ADDENDUM

Campus HVAC System Upgrade
Freemont Magnet Elementary School
Bakersfield City School District
566-0018
DSA #03-122640

Date: March 28, 2024

Subject: Addendum #007

ADD-007.01

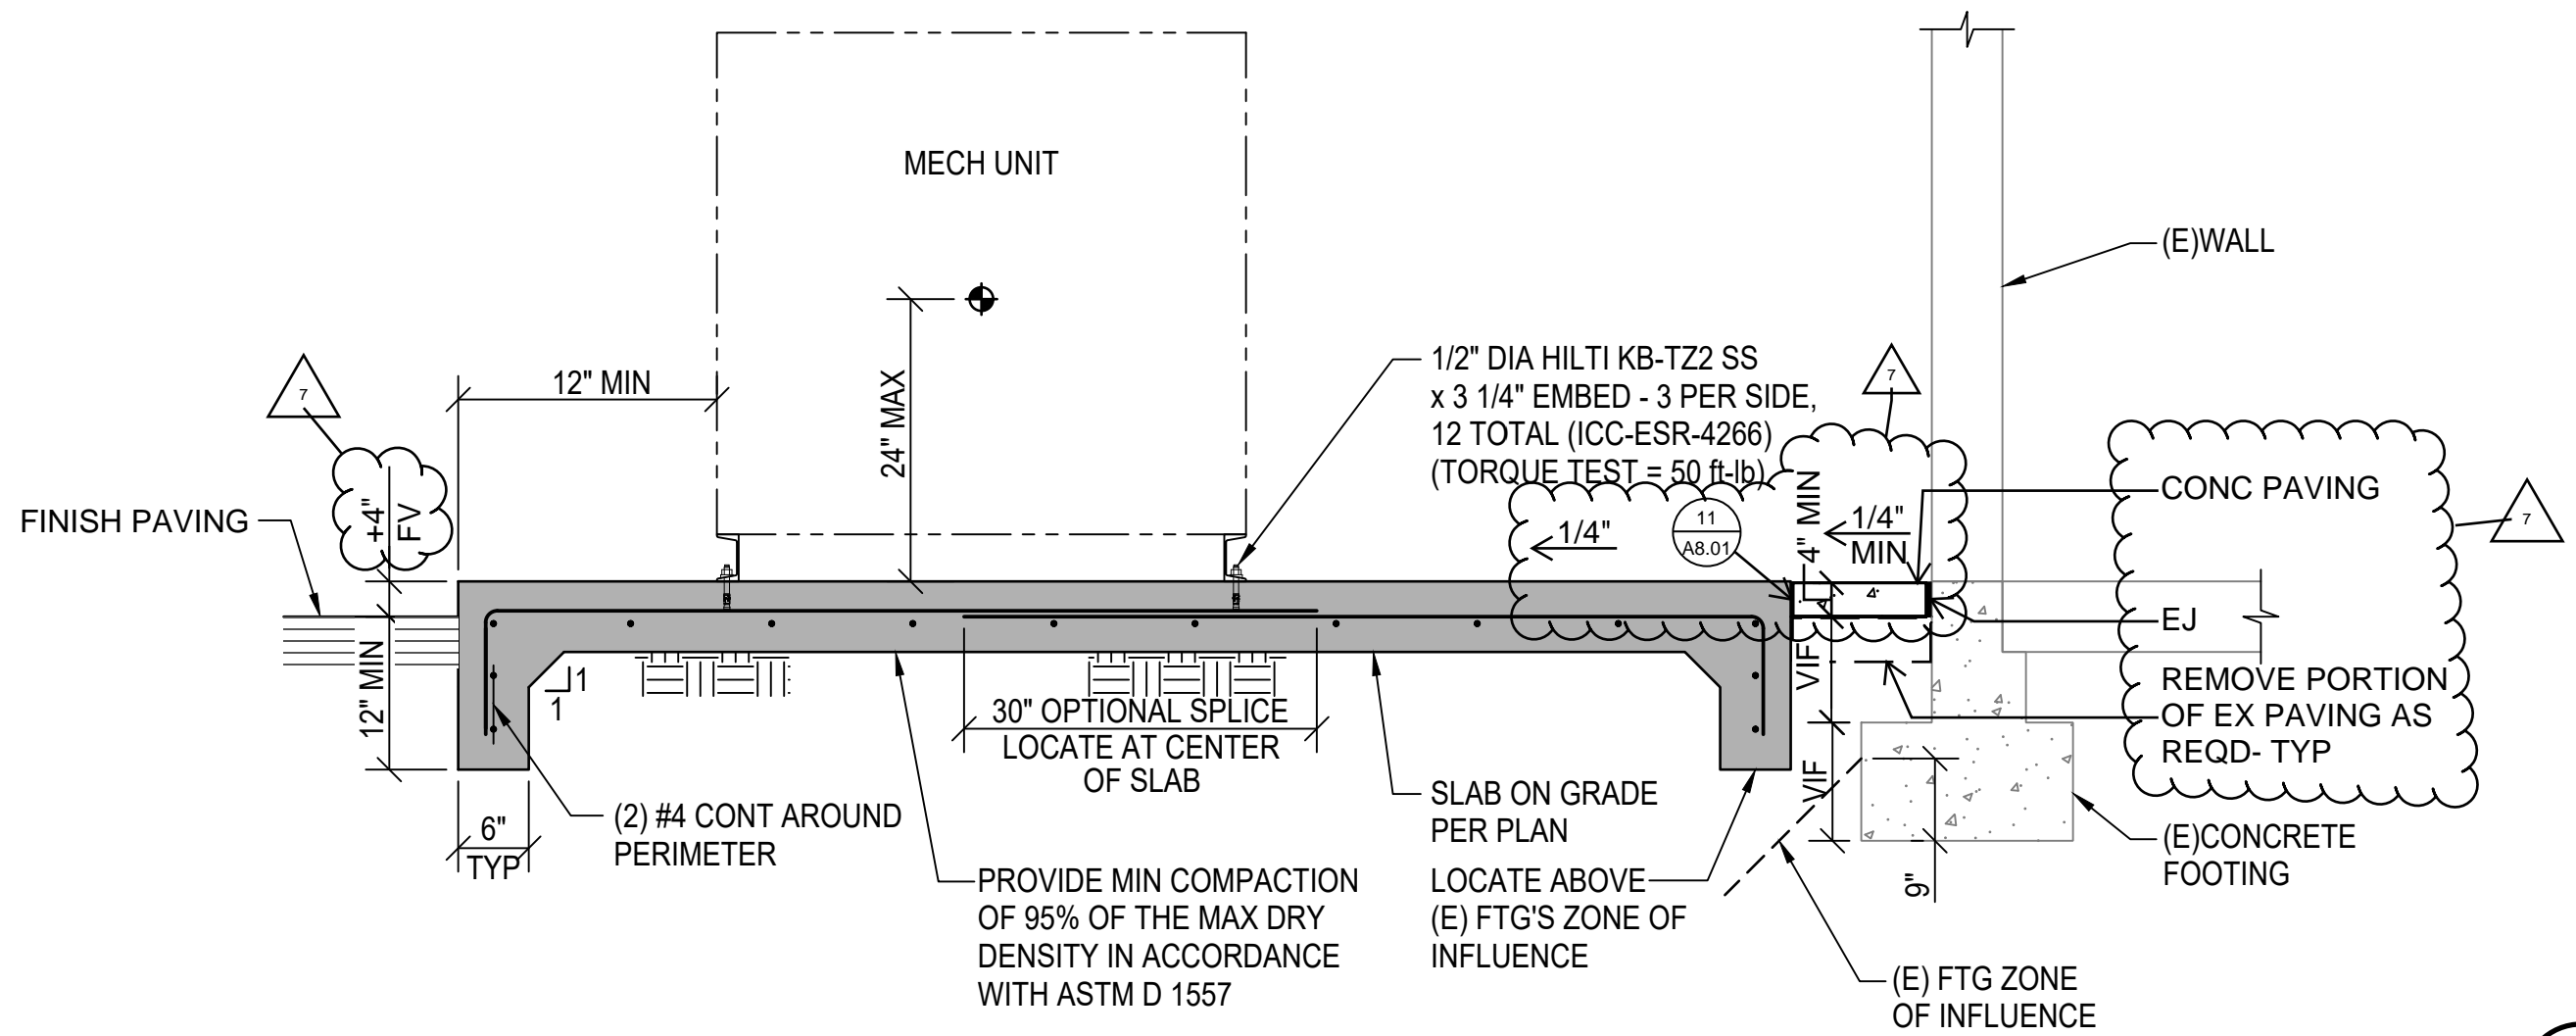
7.2.1 Refer to Sheet A1.22:

- 7.2.1.1 Revise Detail “C” as indicated on attached Detail **ADD-007.01** as denoted by clouded areas with Delta “7”.
